The Fourth Technical Committee was appointed by the USACE to conduct an assessment and evaluation of the accounting procedures and methodology used in the determination of diversion from Lake Michigan and to ascertain whether or not the methods are in accordance with the best current engineering practice and scientific knowledge, as stipulated in the 1980 modified Decree of the U.S. Supreme Court. This review is to be performed by a Technical Committee appointed every five years, and a report evaluating the accounting and operational procedures is to be presented to the USACE and to other interested parties.

The Fourth Technical Committee was appointed by the USACE in July of 1998 and convened in September of 1998. The Committee was appointed to conduct a comprehensive review of the current diversion accounting procedures. The review included the following: 1.) current accounting results; 2.) current diversion related measurement techniques at the Romeoville acoustic velocity meter (AVM) site, the Lockport control structures, precipitation gages, and other pertinent structures; 3.) procedures used to calculate and verify flows that are not directly measured; and 4.) status of reco

Figure 4.2-h - Discharge coefficients and gate openings for sluice-gates at the Chicago River Controlling Works.

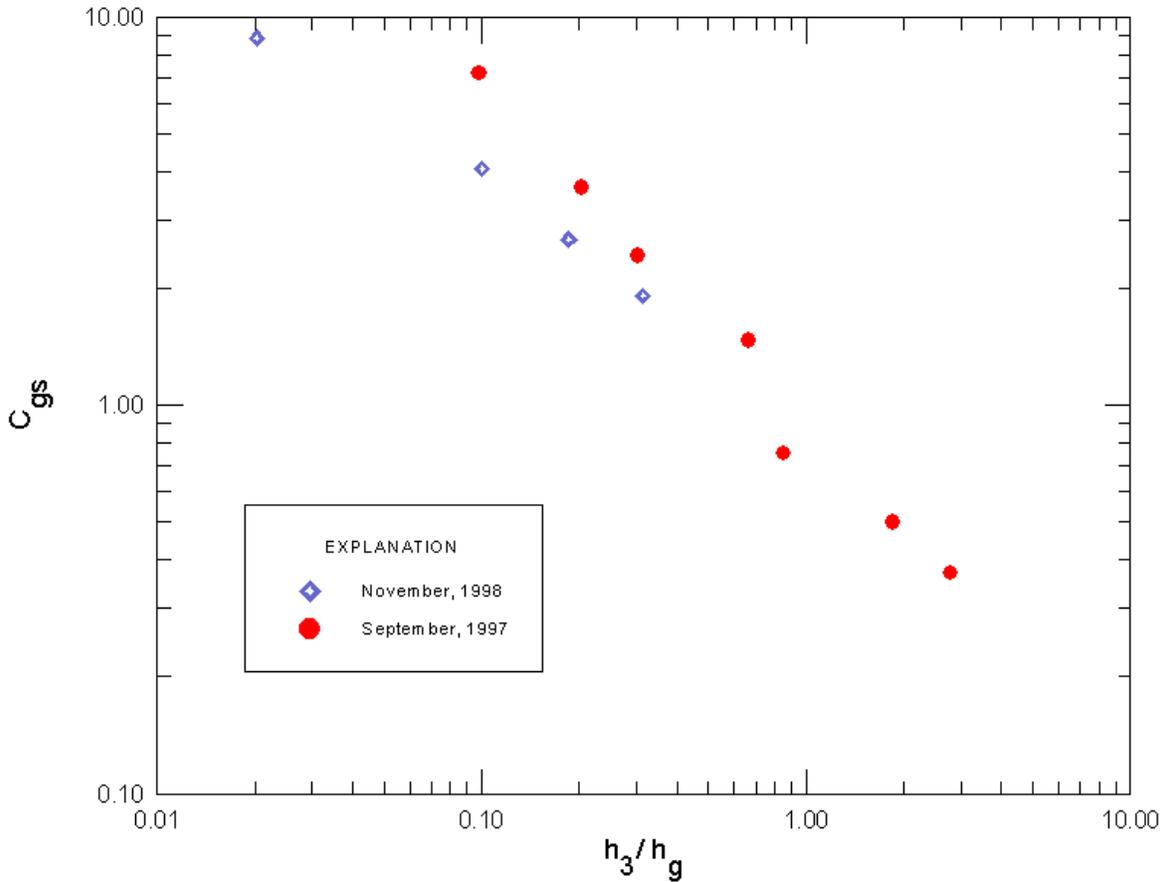
Figure 4.2-h shows the values for the discharge coefficient, C_{gs} compared to the gate opening (h_3/h_g) for both sets of measurements.

This equation has a standard error of -32 percent to +47 percent. Based on the limited measurements available, the estimated error in the discharge from the backup equations ranged from -145 to +156 ft³/sec for the 1-foot gate opening to -2,200 to +3,240 ft³/sec for the 40-foot gate opening.
